Product Change Notification: PCN-23-175451

change to mechanical riveting

HVP-HD1000 90Deg header EC

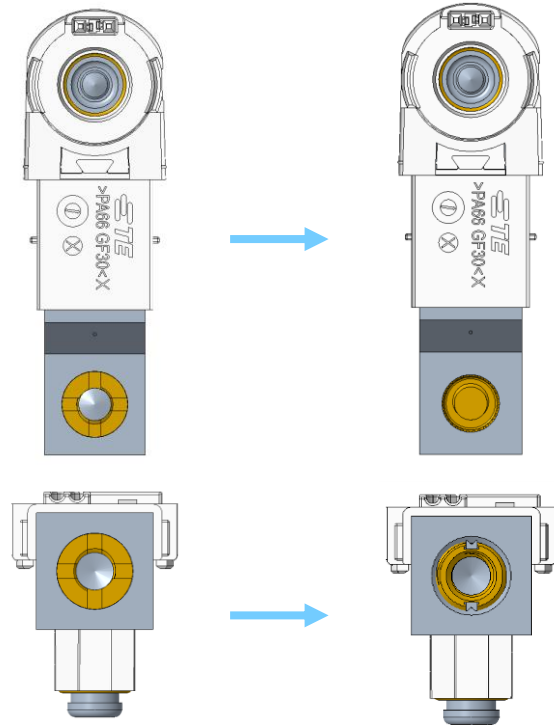
Change to rivet nut to ensure a better performance on holding force & break loose torque
